Application Number
167621
Sheet
88 of 208

WATER AND SEWERAGE NETWORK
300x300 Toilet
WATER AND SEWERAGE NETWORK
300x300 Toilet
FAILS TO COMPLY

The design depicted in this document is not accepted because it fails to comply with conditions listed on the accompanying statement.

SPACELAB
KOSTANTINOU DEVELOPMENTS PTY LTD
arom
MITCHELL CHILDCARE CENTRE
BLOCK 18 SECTION 11
MITCHELL, ACT
DRAWING: LANDSCAPE PLAN
LEVEL 2
PROJECT NO: 171722
DRAWING NO: L201.3
SCALE: DA
REVISION: C
DATE: 11/05/2017
BY: [Signature]
CHECKED: [Signature]
APPROVED: [Signature]

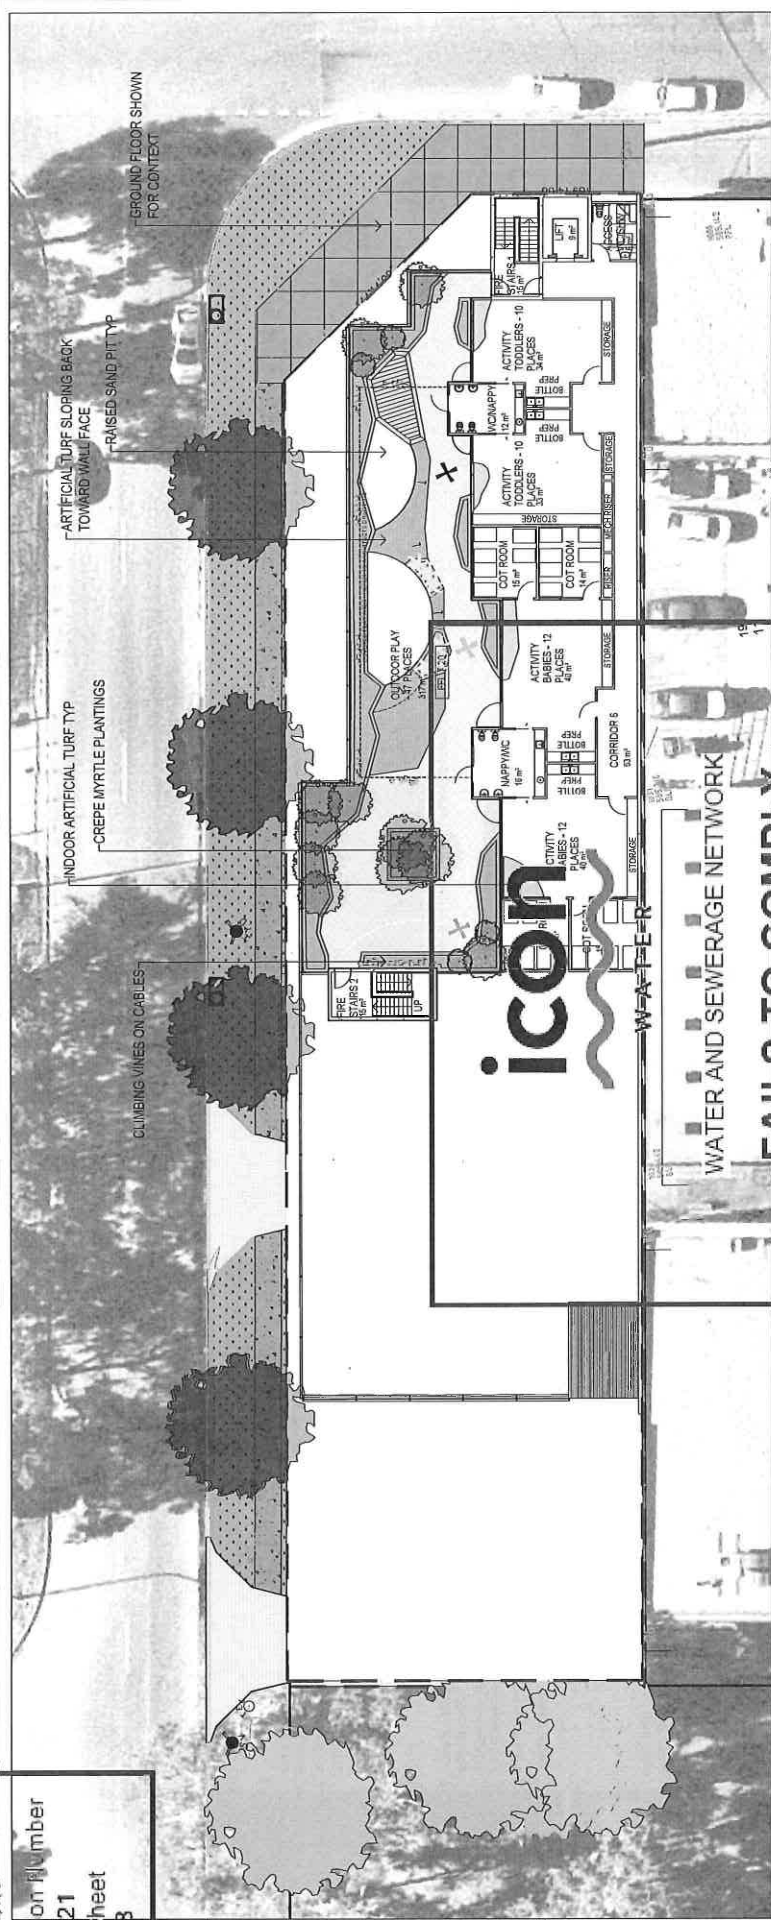
The design depicted in this documents is not fit for purpose and fails to comply with conditions 18 and 19 of the planning permit statement.

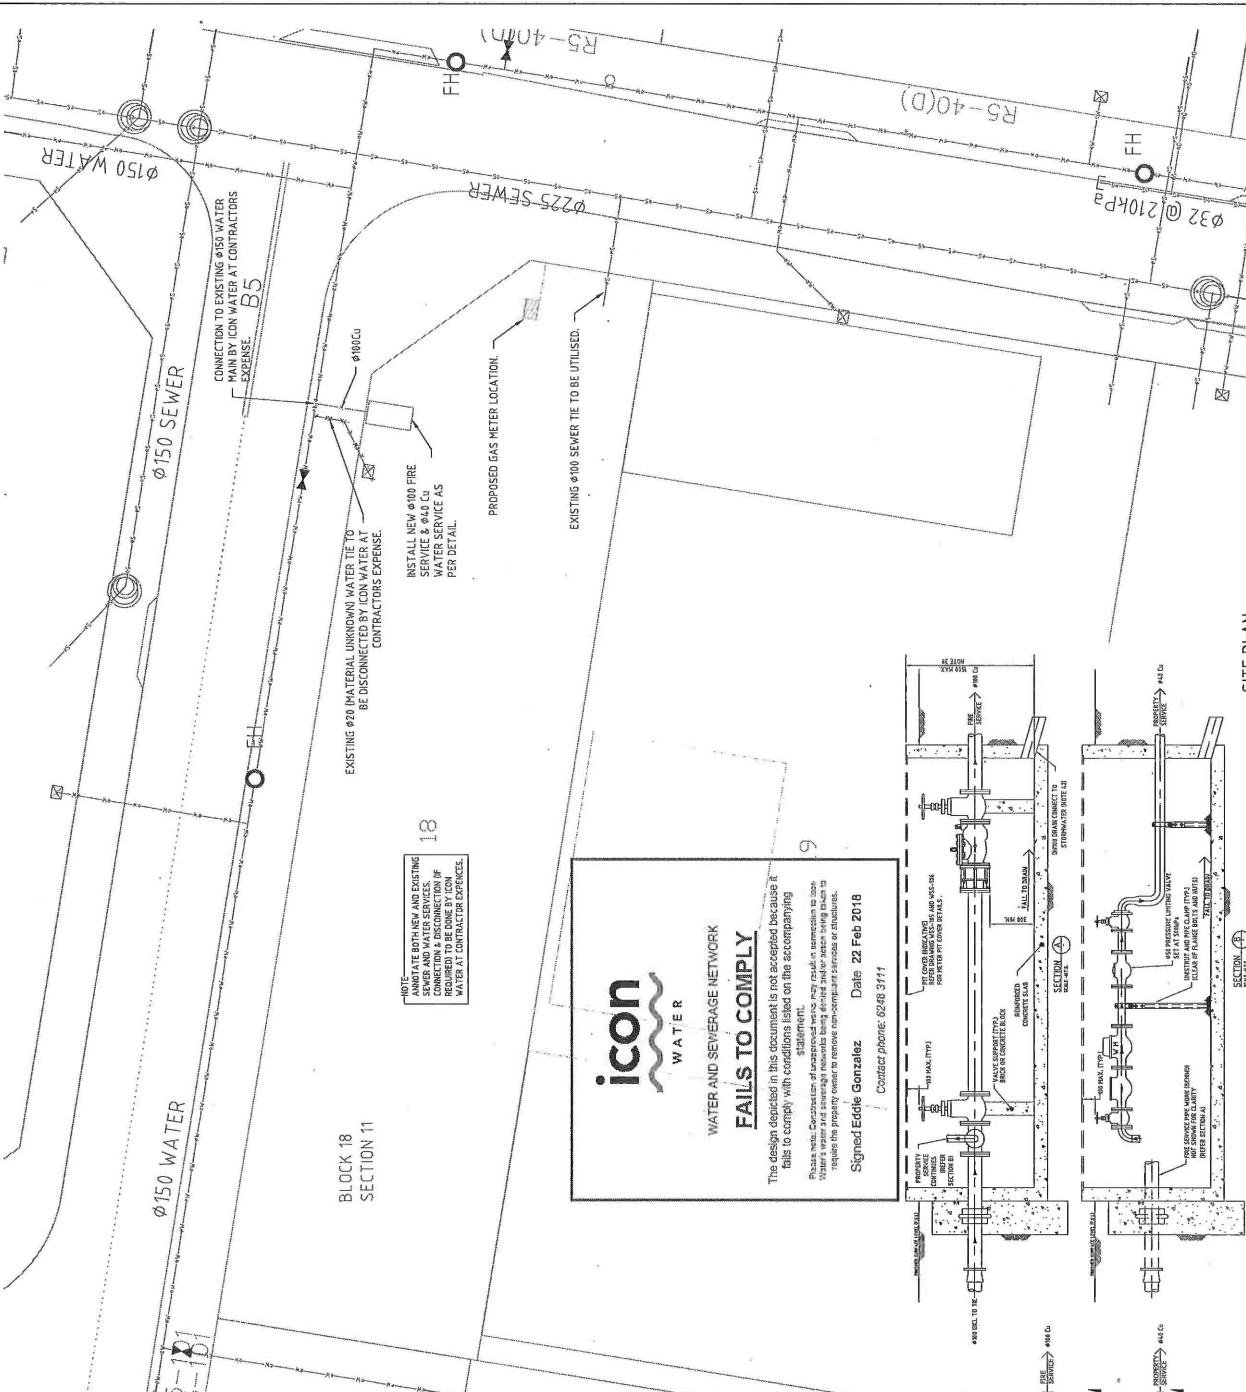
WATER AND SEWERAGE NETWORK FAILS TO COMPLY

The design depicted in this document is not accepted because it fails to comply with conditions listed on the accompanying Plans note. Completion of unapproved work may result in connection to icon Water's sewer and stormwater networks being denied and/or action being taken to require the property owner to remove non-compliant services or structures.

| Project Name | Project Location | Project Number |
|---------------------------|-----------------------------------------------------------------------|----------------|
| MITCHELL CHILDCARE CENTRE | BLOCK 18, SECTION 11 CORNER DARLING & HEFFERNAN STREET, MITCHELL, ACT | SK 200 |

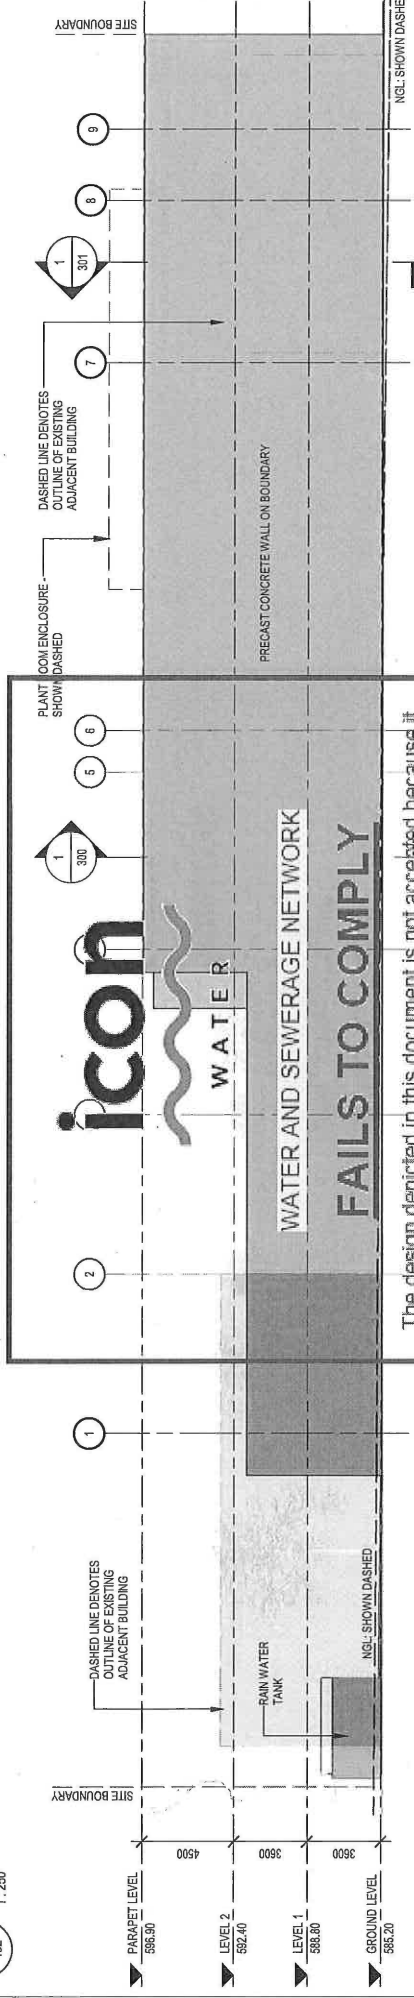
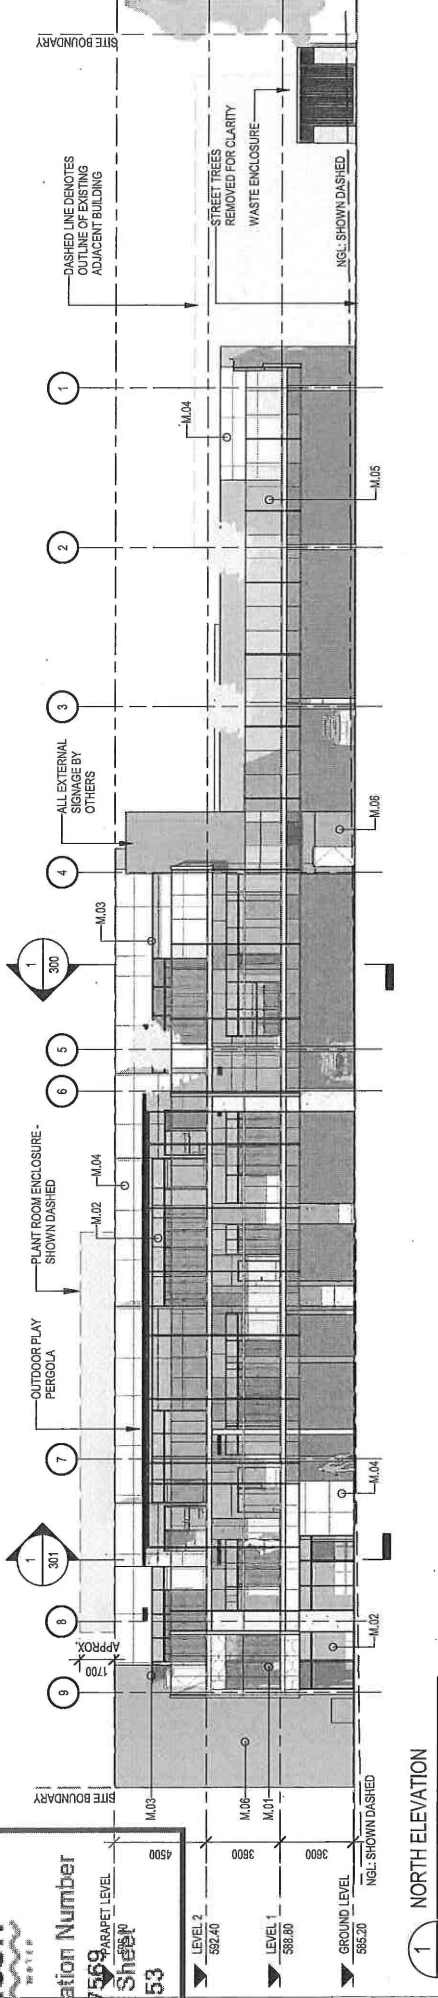
WATER AND SEWERAGE NETWORK FAILS TO COMPLY

The design depicted in this document is not accepted because it fails to comply with conditions listed on the accompanying statement.
